# ADDENDUM NO. 3

Rochester City School District

Dr. Walter Cooper, School #10

March 7<sup>th</sup>, 2018

**AD3-S002**

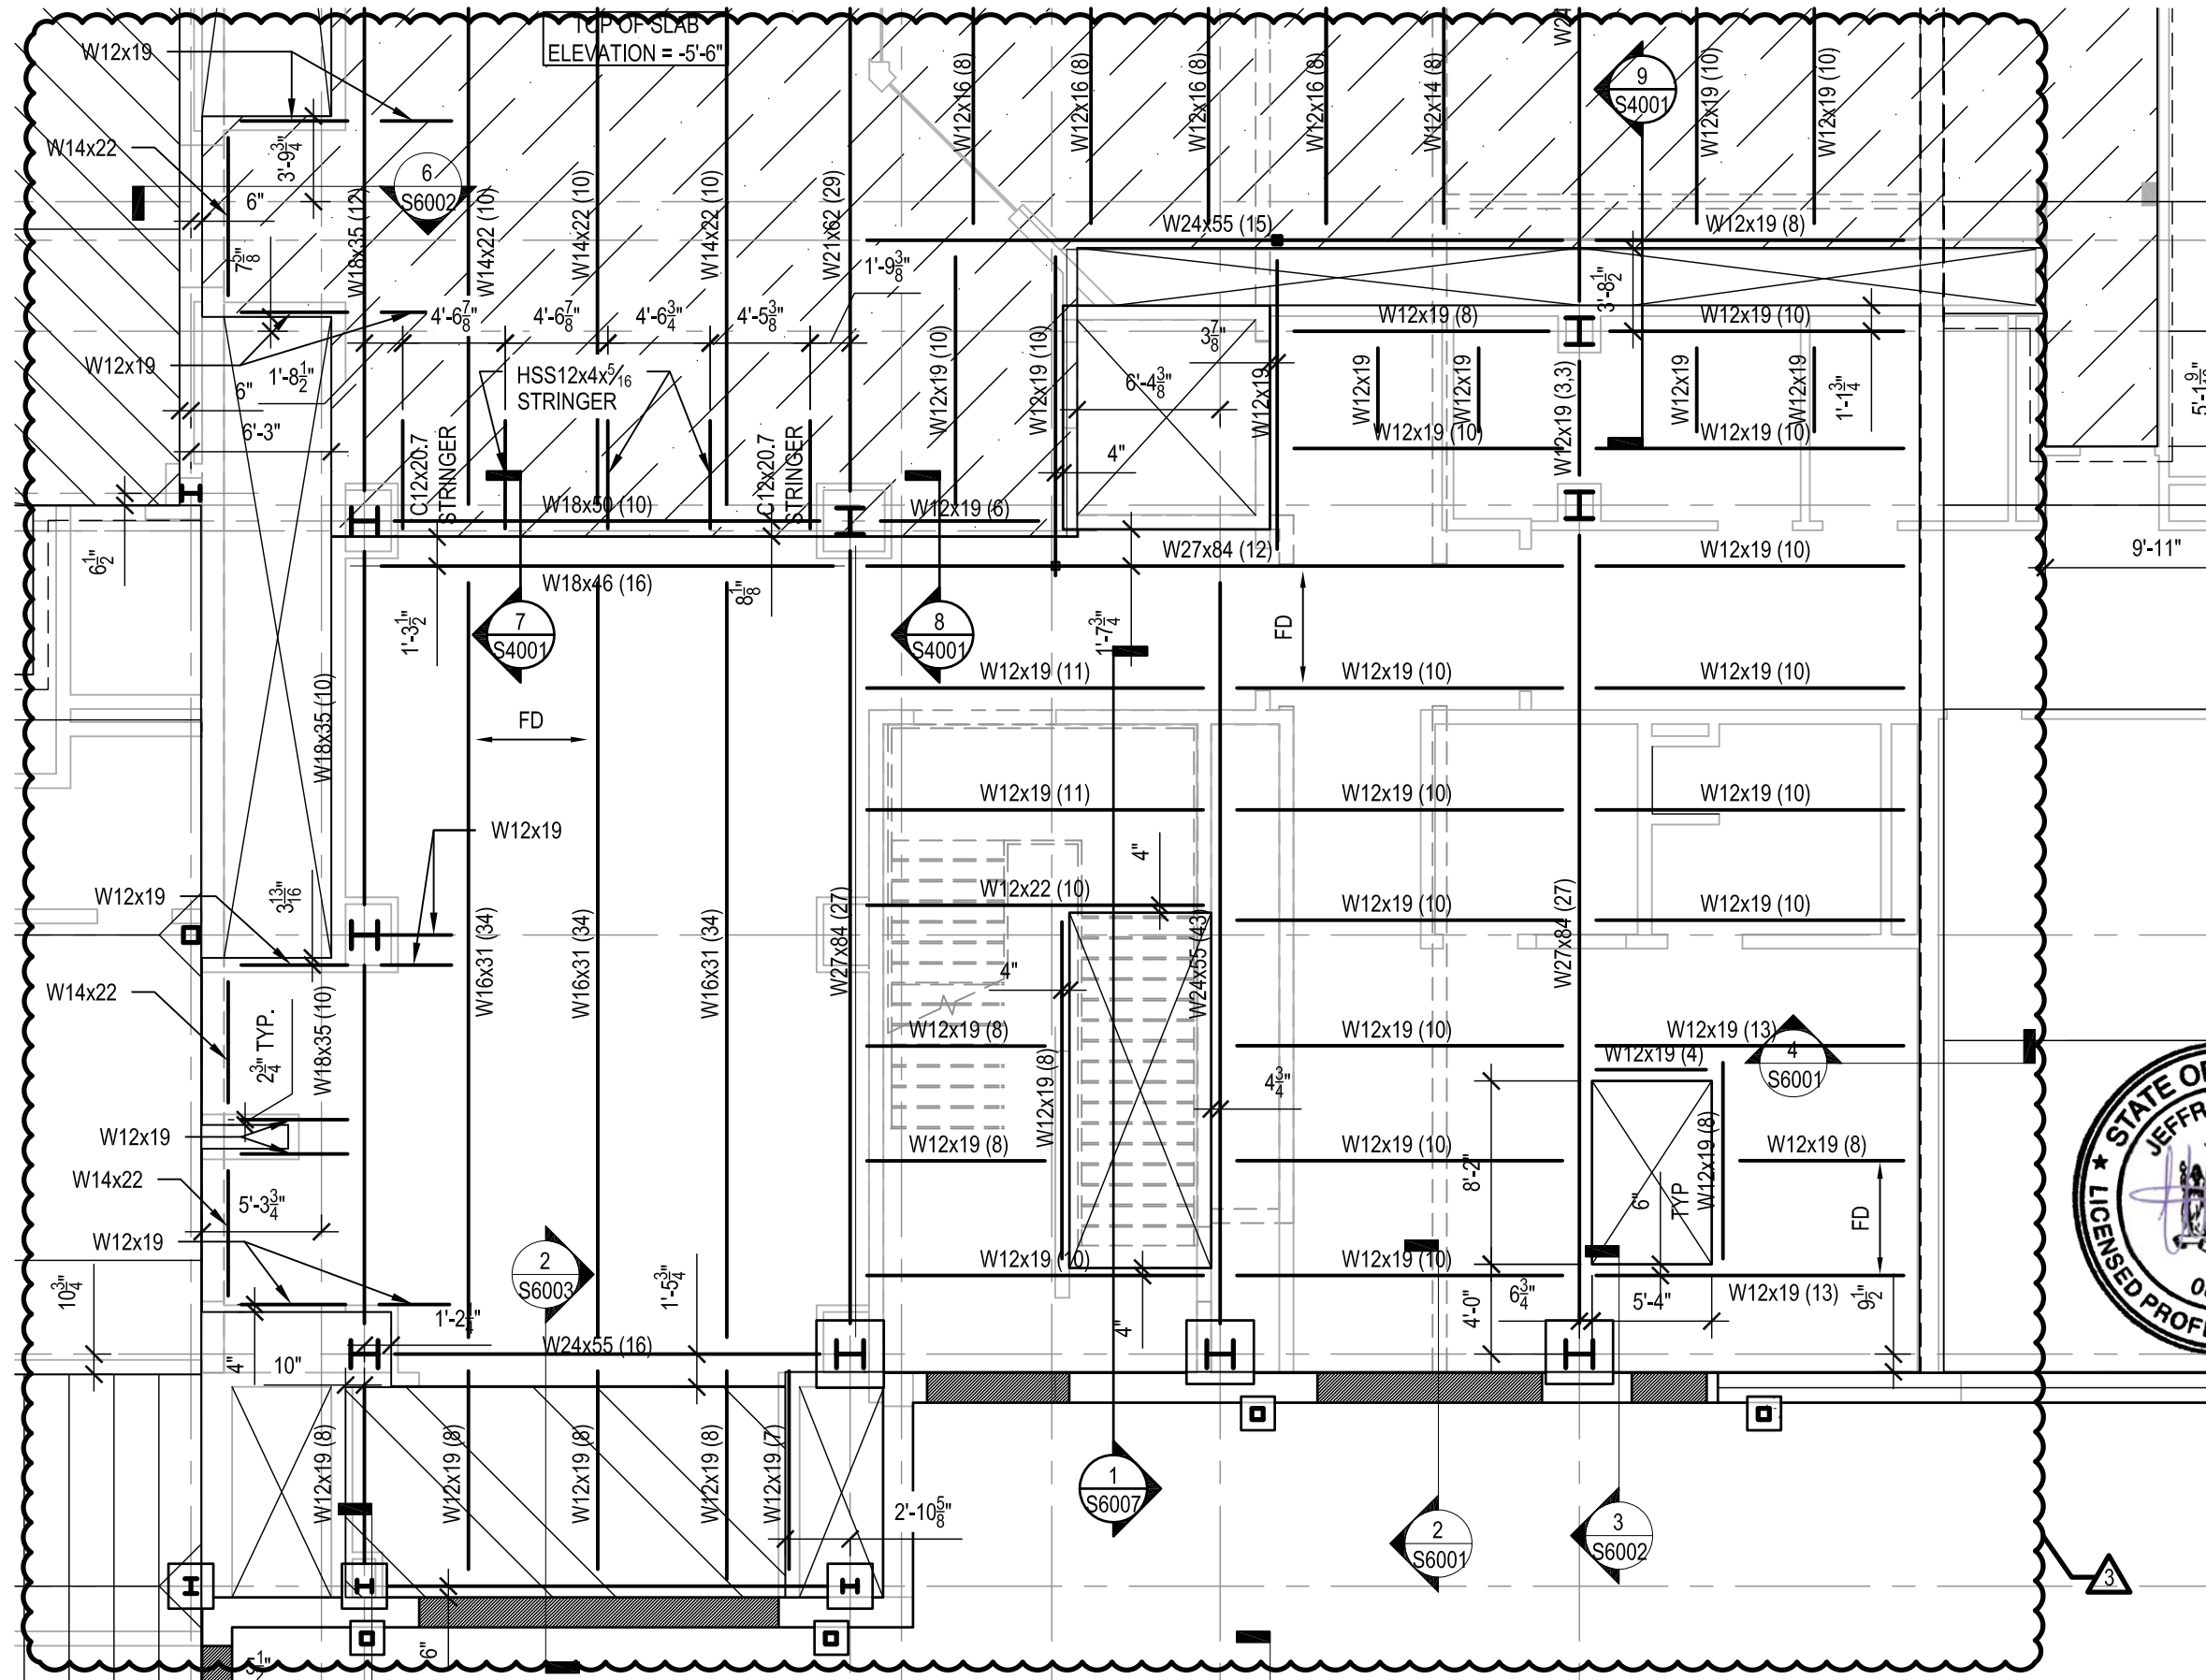
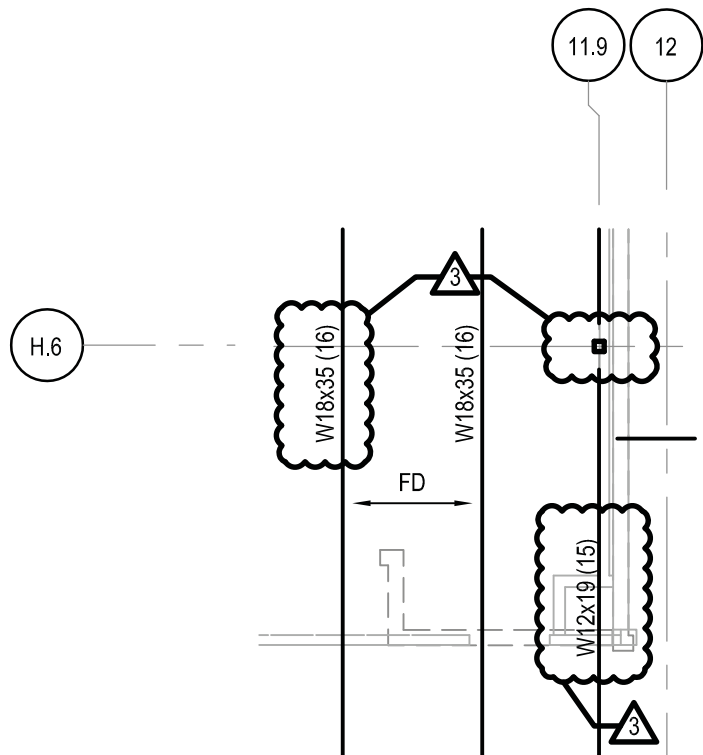
- Item AD3-37 **CLARIFICATION:** Interior non-load bearing masonry partition walls shall bear on thickened slab-on-grade per First Floor Framing Notes #6.  
Item AD3-38 **ADD** attached sketch "AD3-S002 – PARTIAL 1<sup>ST</sup> FLOOR FRAMING PLAN," revising deck edge of elevated 1<sup>st</sup> floor at the east entrance to the event lobby; adding Section Mark 7/S4001 at event lobby stair; adding Section Mark 8/S4001 at bench seat at event lobby; adding Section Mark 9/S4001 at mechanical shaft adjacent to elevator E-01.

**AD3-S003**

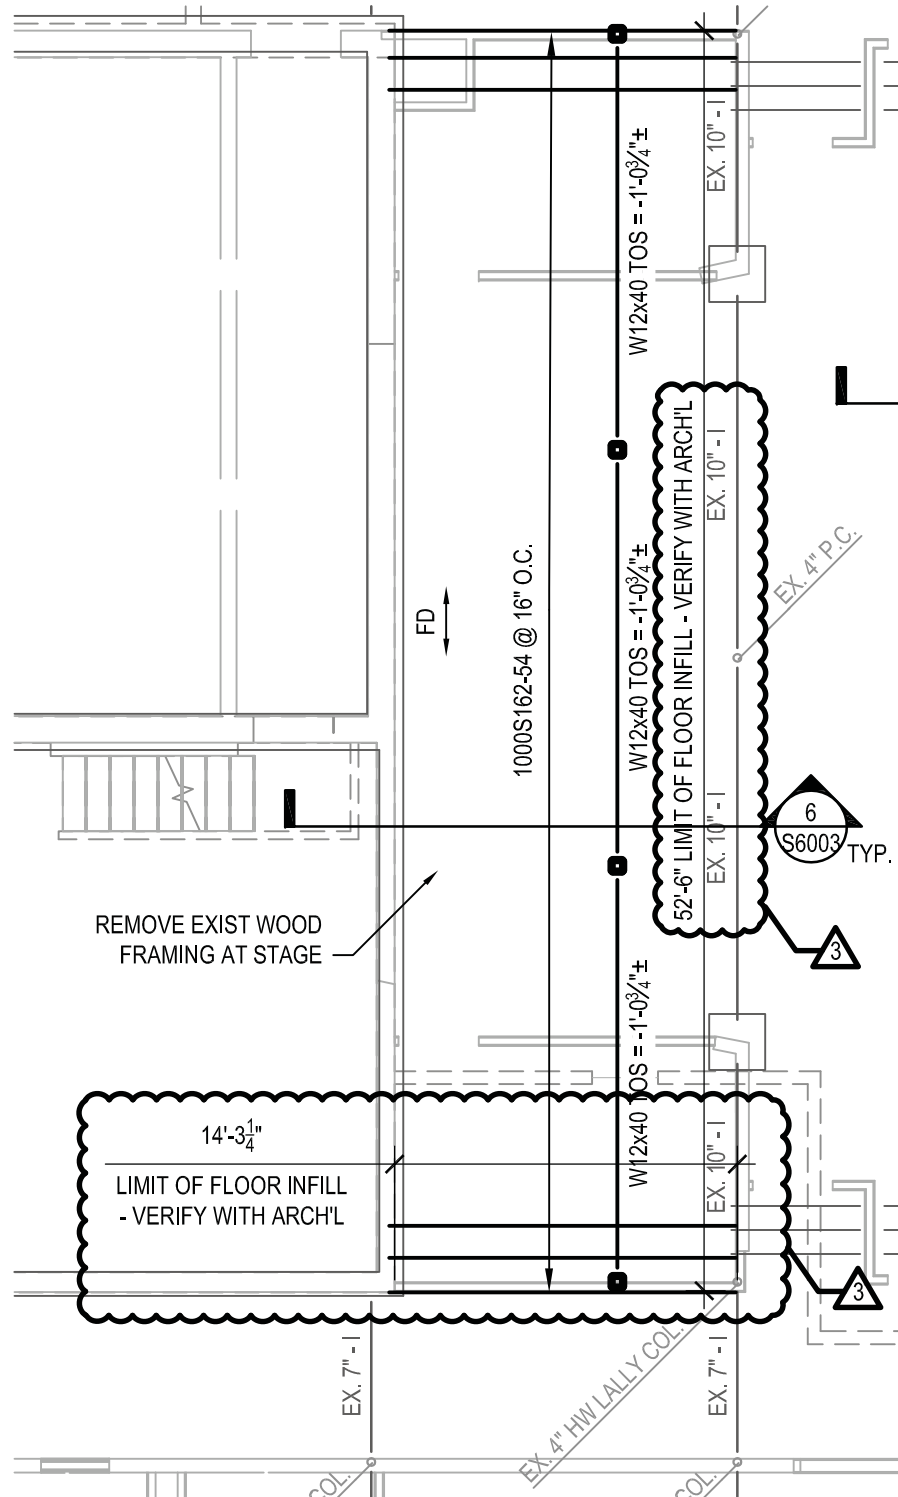
Item AD3-40 **ADD** Section Mark 7/S4002 at east concrete ramp.  
Item AD3-41 **ADD** attached sketch "AD3-S003 – PARTIAL 1<sup>ST</sup> FLOOR FRAMING PLAN," revising beam size and removing additional column at grid lines H.6 & 11.9.

**PARTIAL EXISTING 1ST  
FLOOR FRAMING PLAN -  
STAGE INFILL**

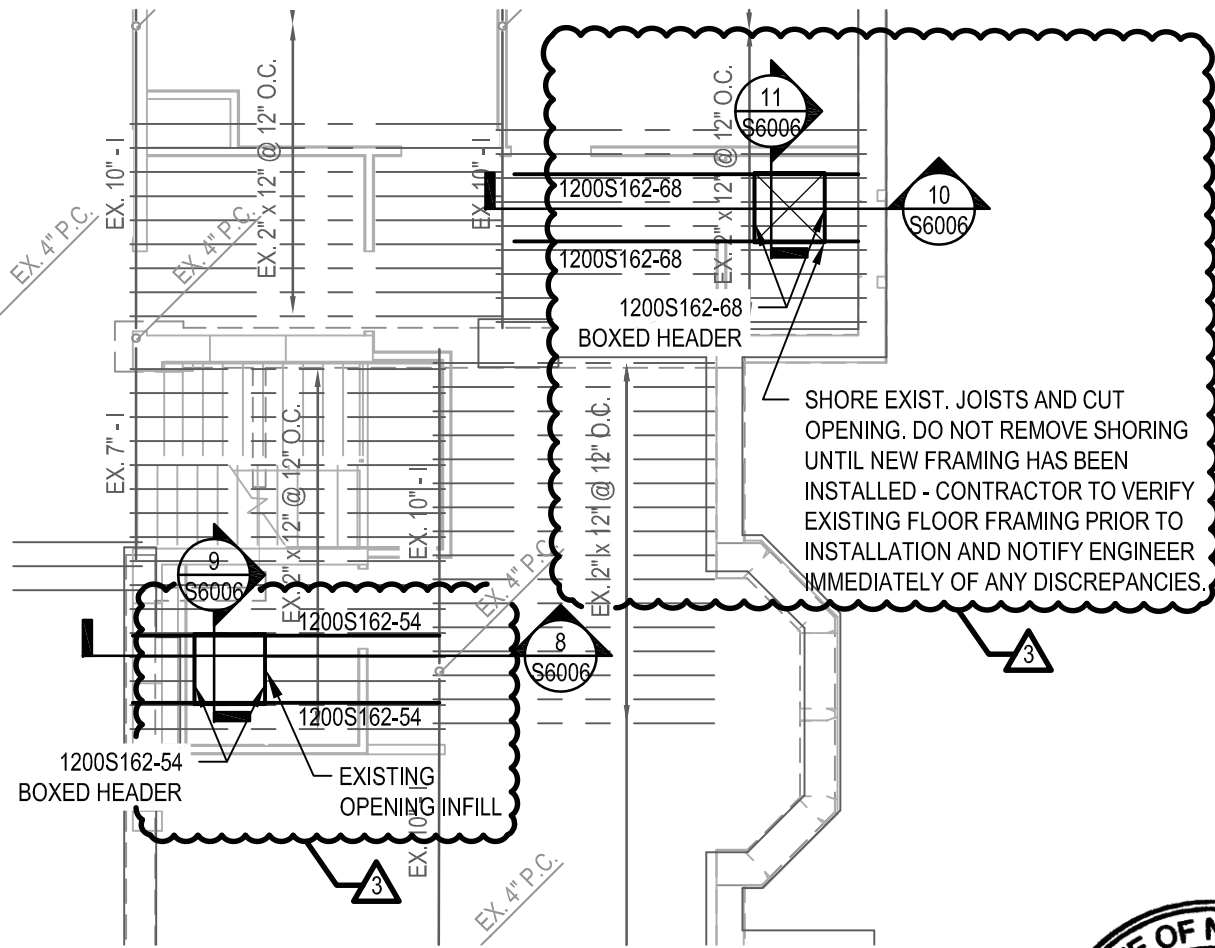
Item AD3-42 **ADD** attached sketch "AD3-S004 – PARTIAL EXISTING 1<sup>ST</sup> FLOOR FRAMING PLAN – STAGE INFILL," revising dimensions of infill limits.

**AD3-S006**

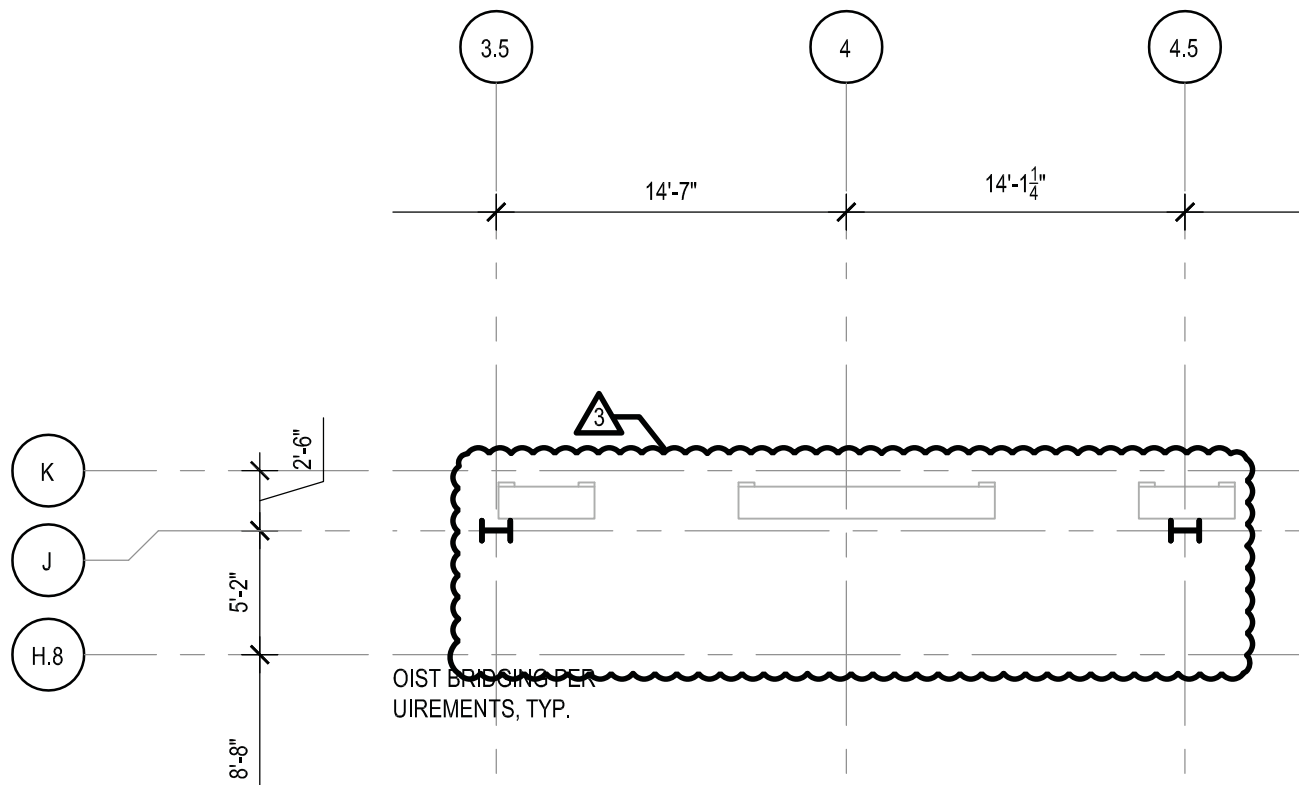
- Item AD3-44 **ADD** attached sketch "AD3-S006 – PARTIAL 2<sup>ND</sup> FLOOR FRAMING PLAN – GYM," deleting vertical bracing along grid line J.
- Item AD3-45 **ADD** attached sketch "AD3-S007 – PARTIAL 2<sup>ND</sup> FLOOR FRAMING PLAN – GYM" adding vertical bracing along grid line 5.
- Item AD3-46 **ADD** attached sketch "AD3-S008 – WEST CANOPY FRAMING PLAN," adding roof deck callout and span direction.

**7** EVENT LOBBY STAIR  
3/4" = 1'-0"

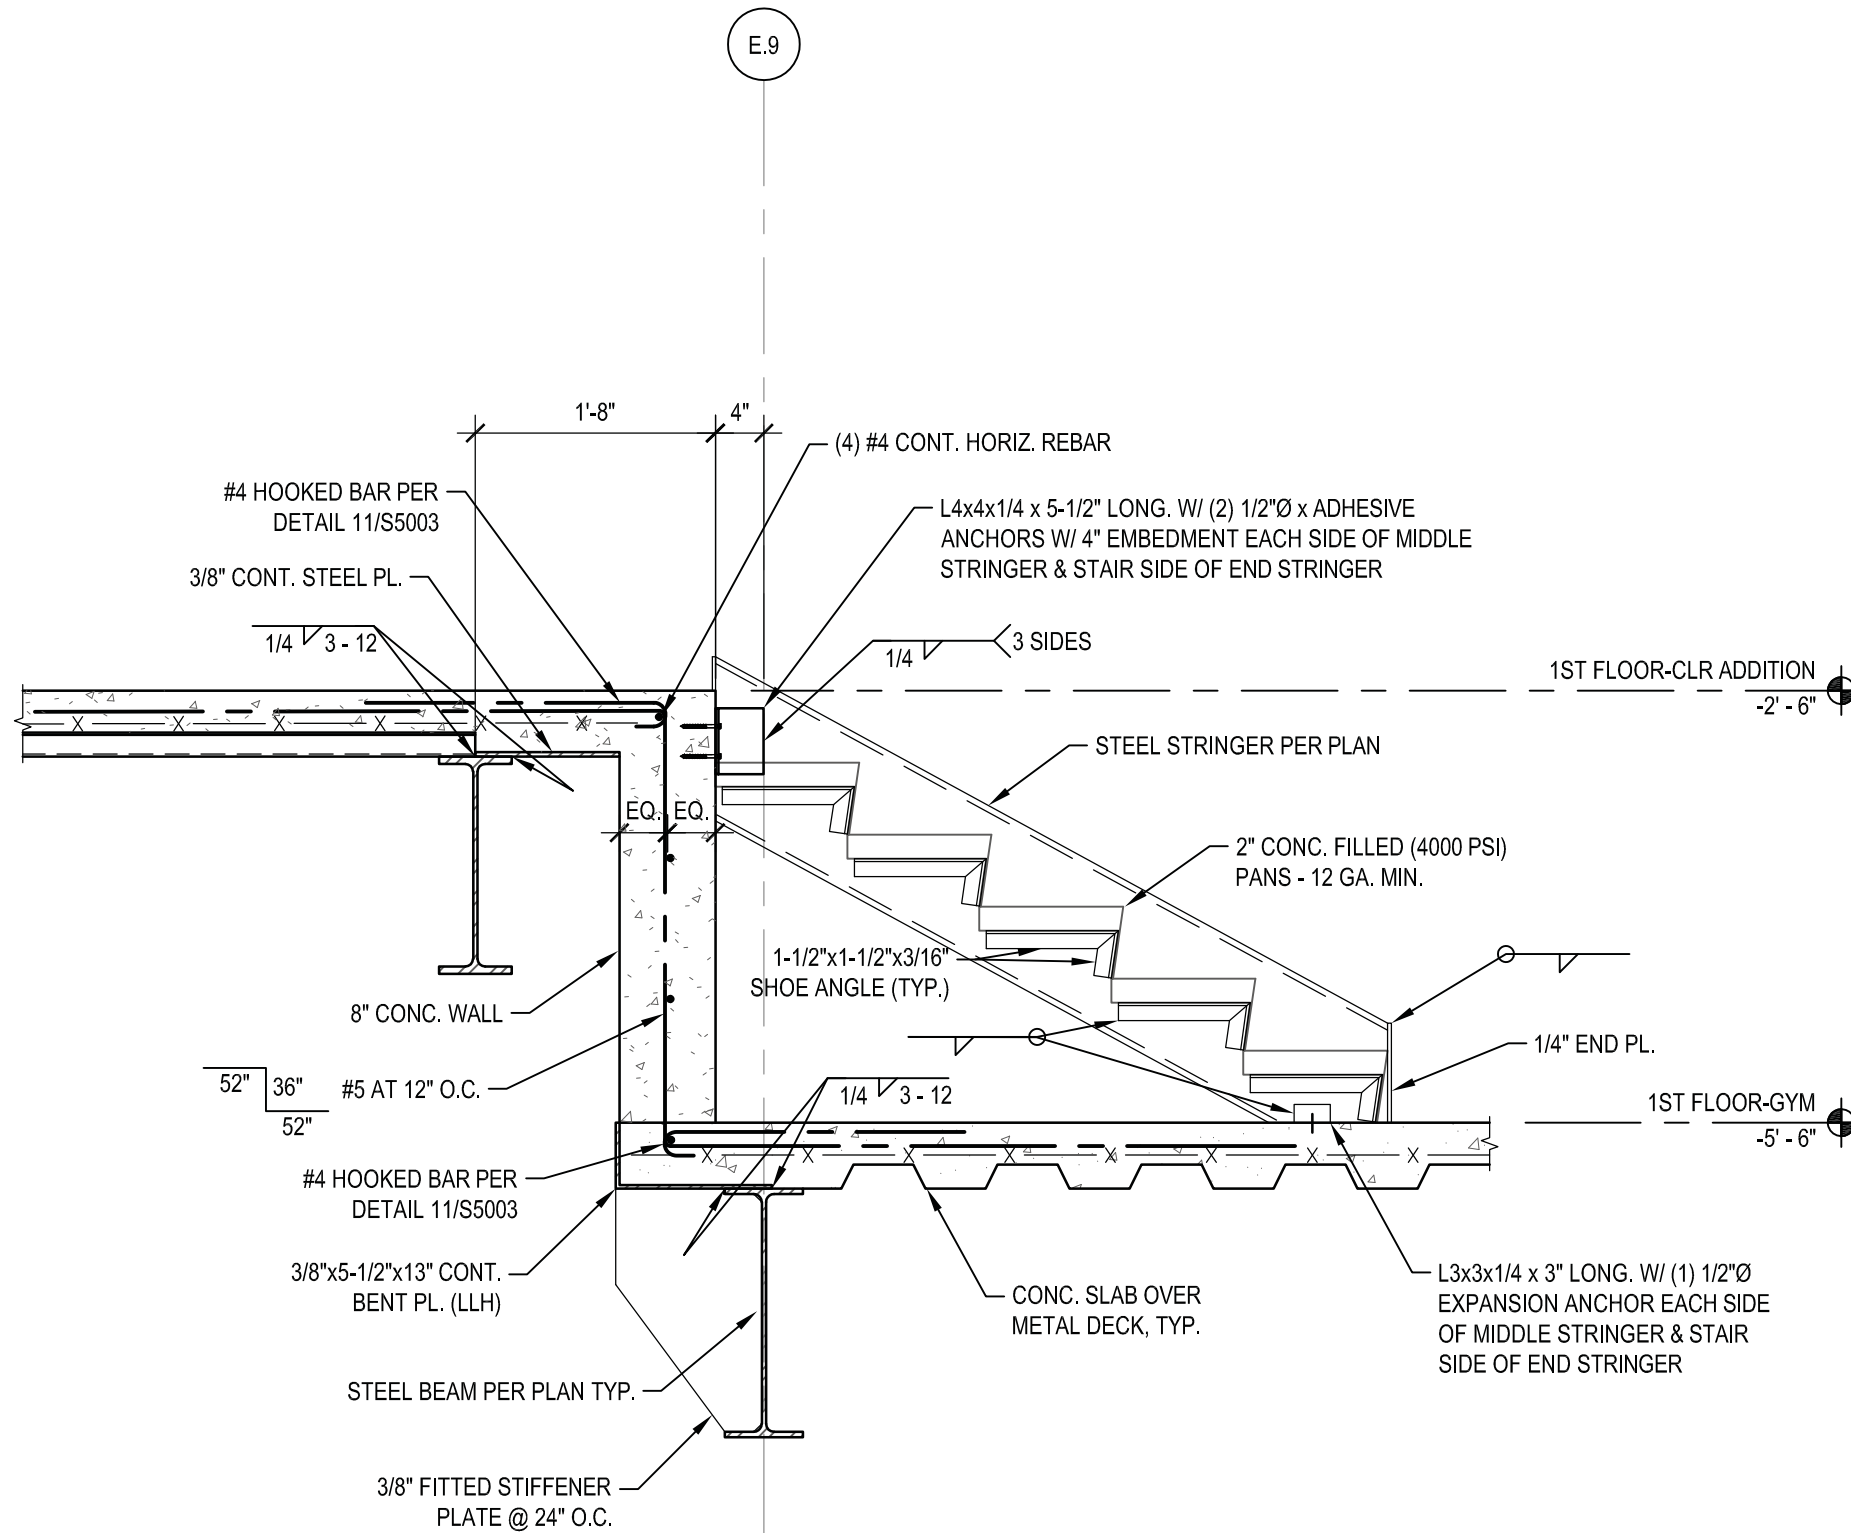
- Item AD3-51 **ADD** attached sketch "AD3-S010 – EVENT LOBBY STAIR," adding Detail 7 to Drawing S4001.
- Item AD3-52 **ADD** attached sketch "AD3-S011 – EVENT LOBBY BENCH SEAT," adding Detail 8 to Drawing S4001.
- Item AD3-53 **ADD** attached sketch "AD3-S012 – FRAMING AND MECHANICAL CHASE AT FLOOR CHANGE," adding Section 9 to Drawing S4001.
